Transport Impact Assessment

Ascension College – Stage 1

3 Nortons Lane, Wantirna South

Version	Date	Issue	Prepared by	Checked by
F01	09/09/2025	Final	J. Hamill-Beach	C. Greenland
F02	04/03/2026	RFI Response	J. Grant & J. Hamill-Beach	C. Greenland

Figure 2.8: Existing Traffic Volumes (School Peak Hours)

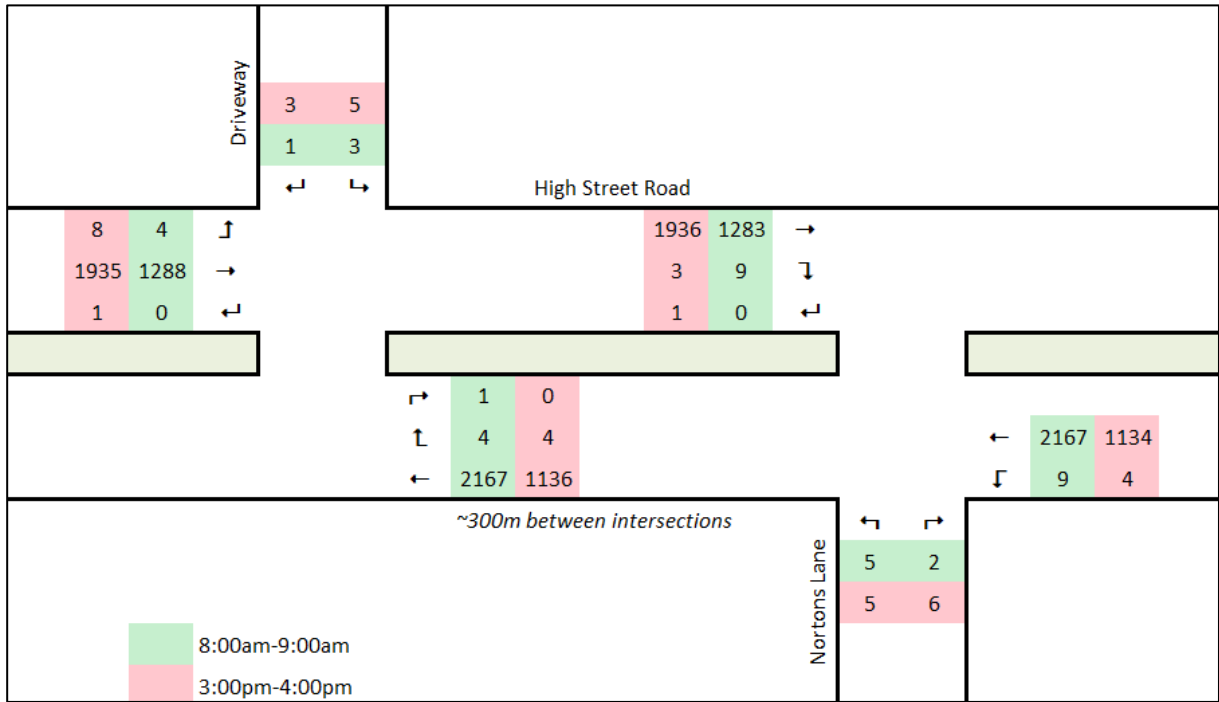
- a. operational analysis of the High Street Road and Nortons Lane intersection during school peak periods under existing and post-development conditions*
- b. assessment of redistributed traffic associated with the right-turn restriction, including impacts on U-turn movements on High Street Road*
- c. confirmation of assumed traffic growth and background volumes.*

Traffic volumes surveyed on 3 February 2026 have been adopted as the background volumes (refer to Figure 2.8). No background traffic growth has been applied. Instead, a detailed gap analysis of the existing conditions has been undertaken to establish the available capacity of the affected movements. This approach is considered appropriate given the nature of the intersection control and the reliance on available gaps in the High Street Road traffic stream.
